SF Apparels Ltd. (10322)
SF Fashion Wears Ltd. (10324)
(Site also includes SF Washing Ltd.)

Nayabari, Kanchpur, Sonargaon

03.JUNE.2014

Identified Priority 1 Concerns

SAND PILE LAYOUT

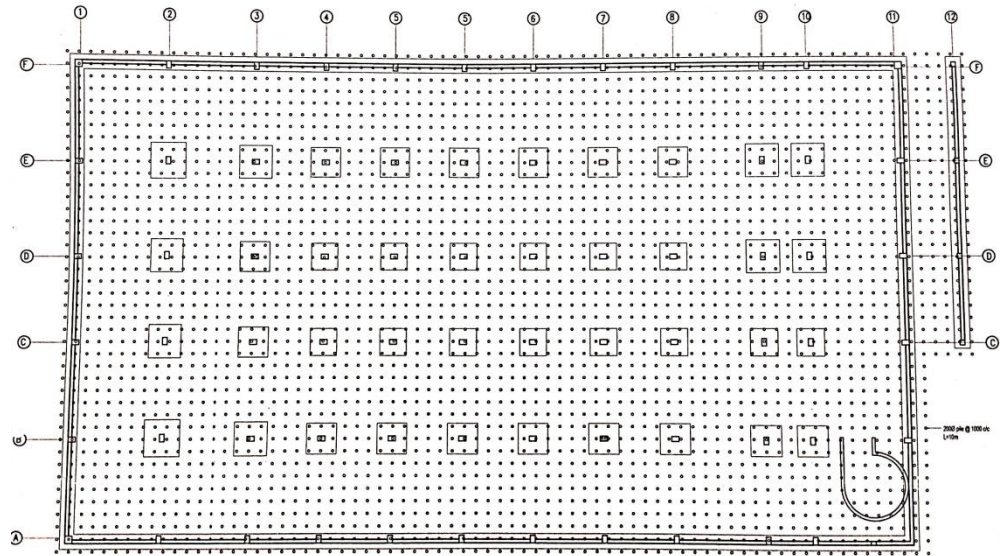
The extract from the Soil Test Report, shown to the left, clearly states a requirement for RC pile foundations.

Above is a structural As-Built drawing showing sand pile ground improvement and individual pad foundations.

There is no reason why this alternative solution should not work, however due to the deviation from Soil Report advice, it is requested that justification for the foundation solution is provided.

4	Priority 3 - Foundation solution applied seems to differ from that suggested in Soil Test Report. Capacity to be confirmed.	Ground bearing capacity of improved ground, strengthened by sand piles, to be established (either by existing Soil Test or calculations, or new Site Investigation). Pressure exerted under installed pad foundations to be calculated following load run-down, and compared with bearing capacity established from previous point.	6-months
5	Priority 3 - Potential for over-stress in internal columns. Further investigation required.	Factory Engineer to review design, loads and column stresses for internal columns. Verify in-situ concrete stresses by 100mm dia. cores from 4 columns. Produce and actively manage a loading plan for all floor plates within the factory, giving consideration to floor capacity and column capacity.	6-months

5th Priority 3 Concern

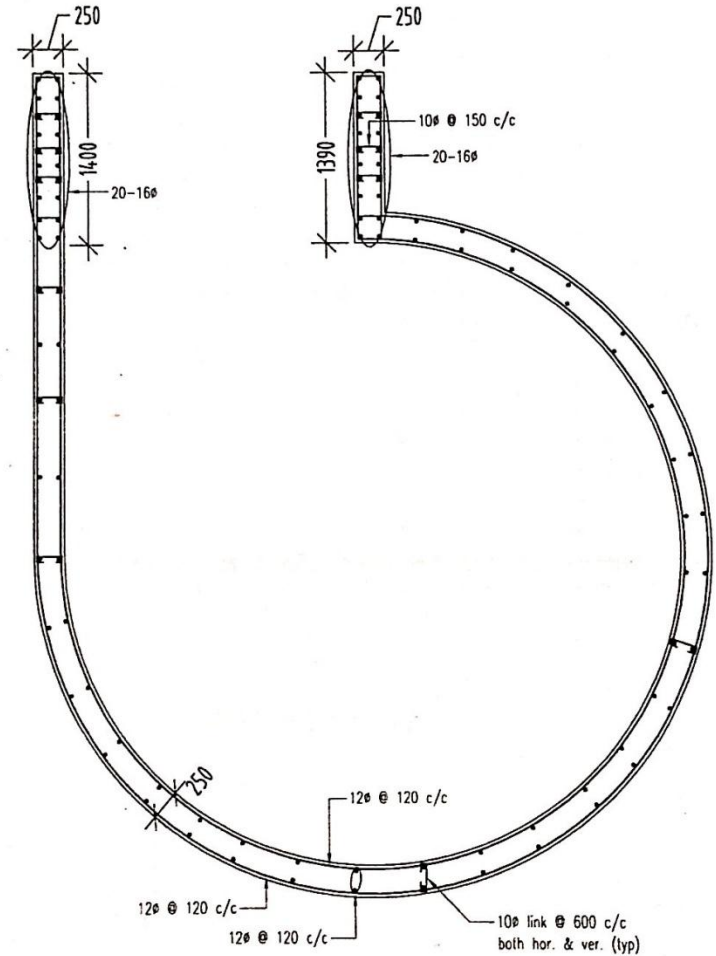
These images show the fairly regular column grid apparent across the building. For the column load run-down, the largest bay in the column grid was located and measured-up.

No significant concerns were raised through this calculation, however the resulting Factor of Safety was low enough to warrant a certain level of further investigation.

After Ferros scanning and measuring, it appeared that the columns had been constructed as shown in the drawings.
